Product Change Notification: DSNO-18SQTN760

CCB 7580 Initial Notice: Qualification of ATP7 as an additional assembly site for selected MIC2875 and MIC2876 device families available in 8L UDFN (2x2x0.6mm) package.

PCN Status: Initial Notification

PCN Type: Manufacturing Change

Lead-Frame Comparison

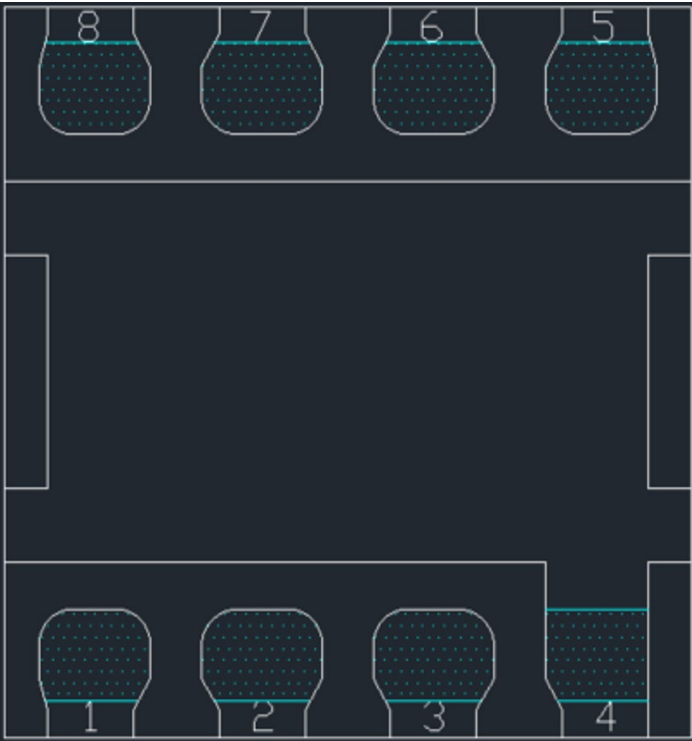
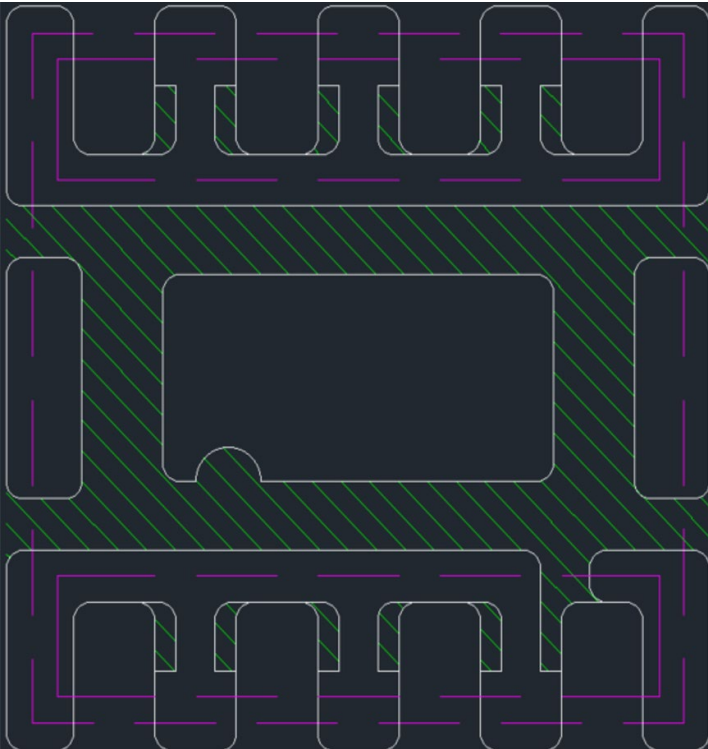
Note: Not-to-scale													
<table><tr><td>Lead-Frame Material</td><td>C194</td></tr><tr><td>DAP Surface Prep</td><td>Spot Ag</td></tr><tr><td>Lead-Frame Paddle Size</td><td>69x41mils</td></tr></table>	Lead-Frame Material	C194	DAP Surface Prep	Spot Ag	Lead-Frame Paddle Size	69x41mils	<table><tr><td>Lead-Frame Material</td><td>C7025</td></tr><tr><td>DAP Surface Prep</td><td>Ring Ag</td></tr><tr><td>Lead-Frame Paddle Size</td><td>67x39mils</td></tr></table>	Lead-Frame Material	C7025	DAP Surface Prep	Ring Ag	Lead-Frame Paddle Size	67x39mils
Lead-Frame Material	C194												
DAP Surface Prep	Spot Ag												
Lead-Frame Paddle Size	69x41mils												
Lead-Frame Material	C7025												
DAP Surface Prep	Ring Ag												
Lead-Frame Paddle Size	67x39mils
